Commission Agenda Report

Subject: Administrative Coastal Development Permit No. 25-035 – An application to install a new onsite wastewater treatment system and associated development

Location: 3930 Ridgemont Drive, partially within the appealable coastal zone

Administrative Coastal Development Permit No. 25-035

3930 RIDGEMONT AOWTS CONFORMANCE REVIEW
DESIGN PLANS
CR-SITE PLANS AND TABLES 11x17
MALIBU, CALIFORNIA

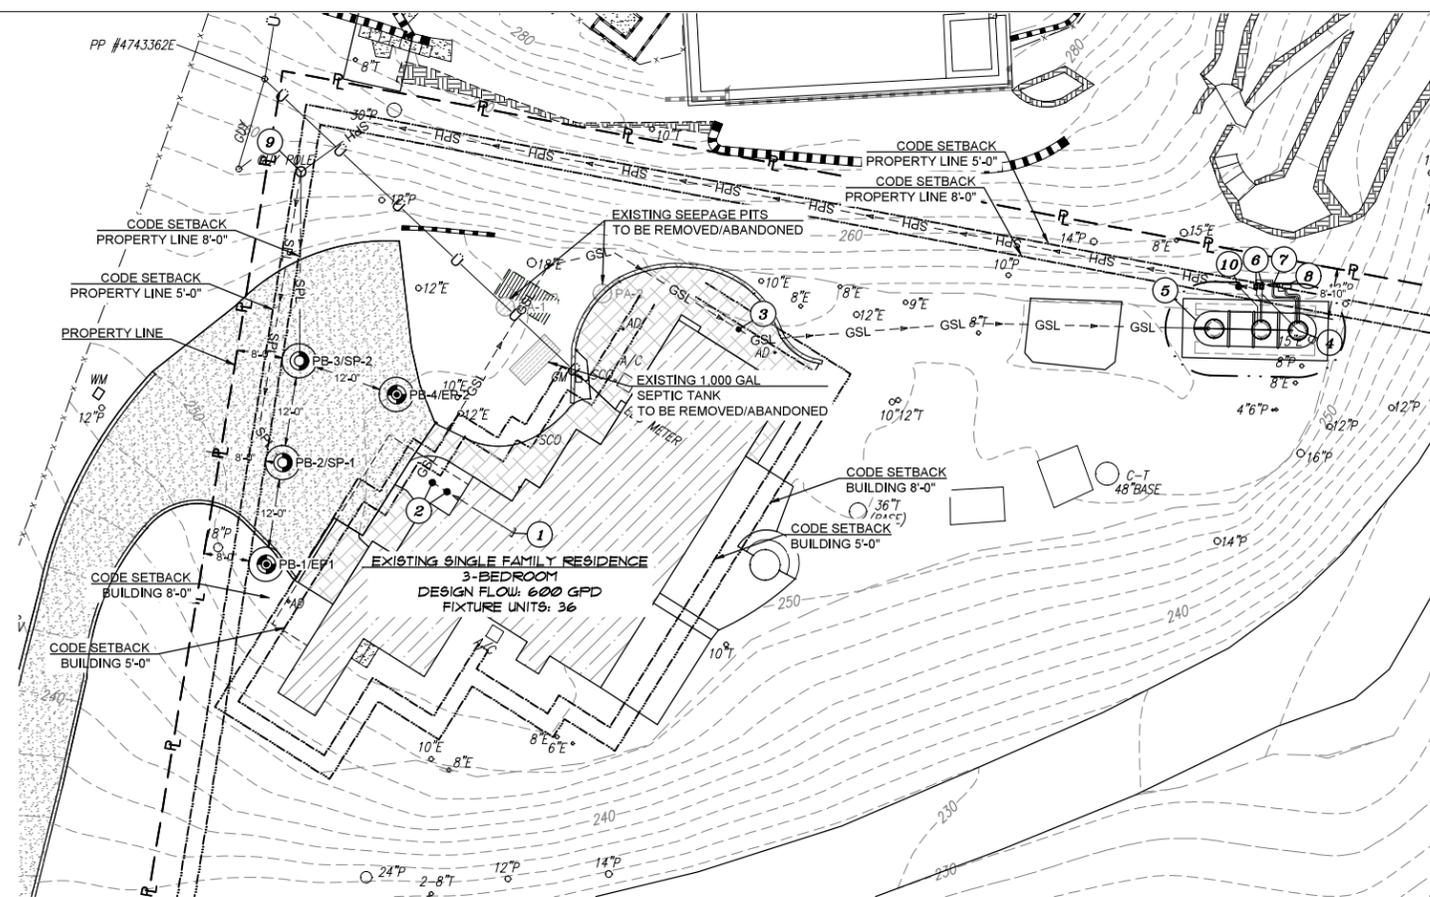
22. Existing OWTS to be Abandoned: Final plans shall clearly show the locations of all existing OWTS components (serving pre-existing development) to be abandoned and provide procedures for the OWTS’ proper abandonment in conformance with the MMC.

23. Worker Safety Note and Abandonment of Existing OWTS: The following note shall be added to the plan drawings included with the OWTS final design: “Prior to commencing work to abandon, remove, or replace existing Onsite Wastewater Treatment System (OWTS) components an “OWTS Abandonment Permit” shall be obtained from the City of Malibu. All work performed in the OWTS abandonment, removal, or replacement area shall be performed in strict accordance with all applicable federal, state, and local environmental and occupational safety and health regulatory requirements. The obtainment of any such required permits or approvals for this scope of work shall be the responsibility of the applicant and their agents.”

3930 RIDGEMONT AOWTS CONFORMANCE REVIEW
DESIGN PLANS
CR-SITE PLANS AND TABLES 11x17
MALIBU, CALIFORNIA

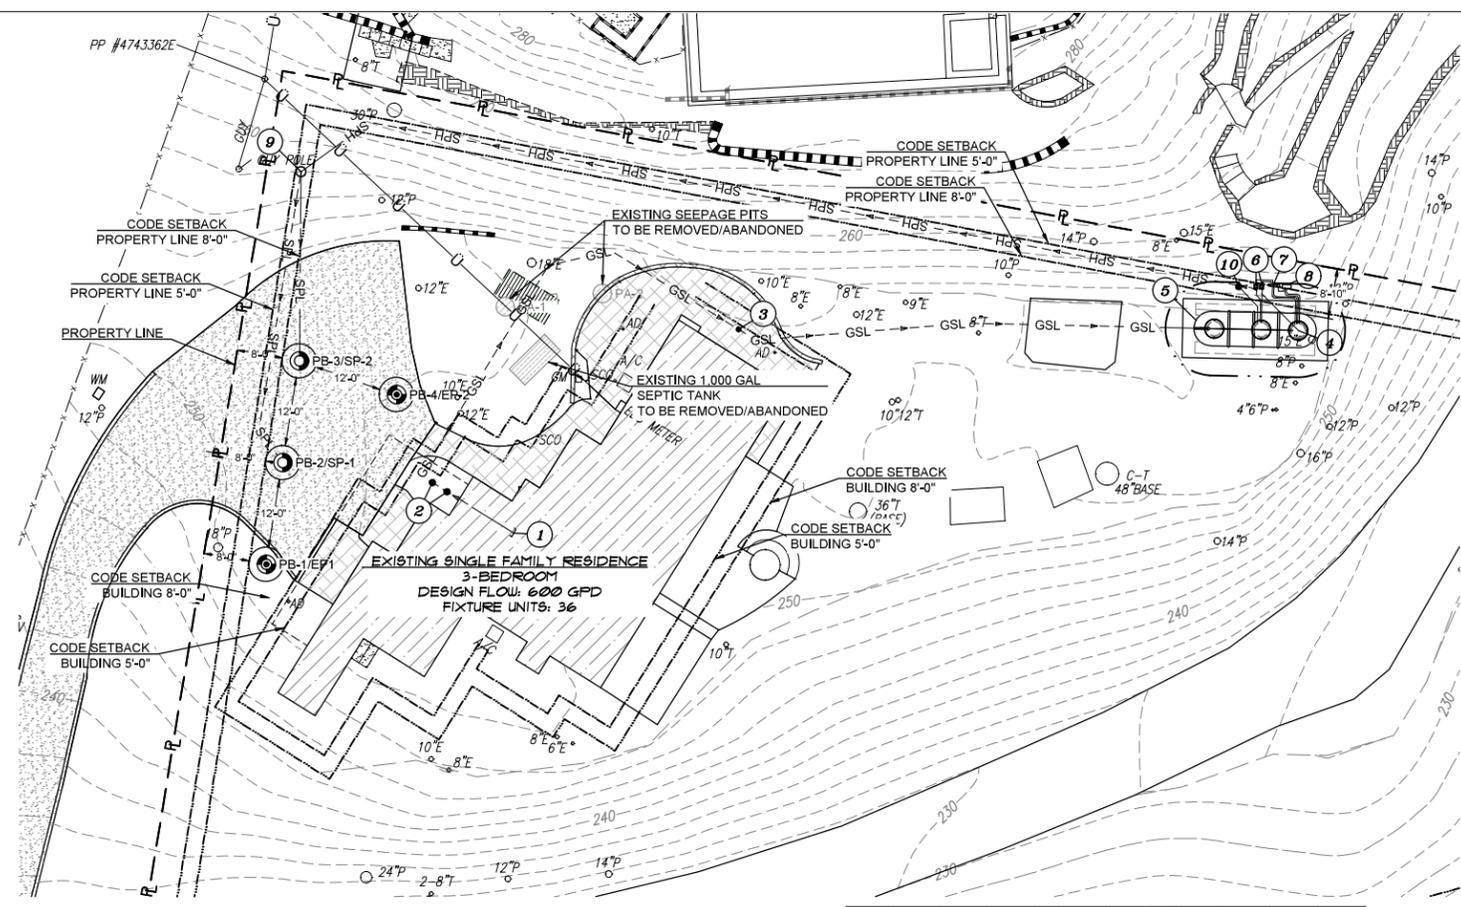
- 1) **Final Onsite Wastewater Treatment System (OWTS) Plot Plan:** A final plot plan prepared by a City Registered OWTS Designer shall be submitted showing an OWTS design meeting the minimum requirements of the Malibu Municipal Code (MMC) and the Local Coastal Program (LCP)/Local Implementation Plan (LIP). The plans must include all necessary construction details, the proposed drainage plan for the developed property, and the proposed landscape plan for the developed property. The OWTS Plot Plan shall show essential features of the OWTS, existing improvements, and proposed/new improvements. The plot plan must fit on an 11" x 17" sheet leaving a 5" left margin clear to provide space for a City-applied legend.

- 3) **Existing OWTS to be Abandoned:** Final plans shall clearly show the locations of all existing OWTS components (serving pre-existing development) to be abandoned and provide procedures for the OWTS' proper abandonment in conformance with the Malibu Municipal Code.

- 4) **Worker Safety Note and Abandonment of Existing OWTS:** The following note shall be added to the plan drawings included with the OWTS final design: *"Prior to commencing work to abandon, remove, or replace existing Onsite Wastewater Treatment System (OWTS) components an "OWTS Abandonment Permit" shall be obtained from the City of Malibu. All work performed in the OWTS abandonment, removal, or replacement area shall be performed in strict accordance with all applicable federal, state, and local environmental and occupational safety and health regulatory requirements. The obtainment of any such required permits or approvals for this scope of work shall be the responsibility of the applicant and their agents."*
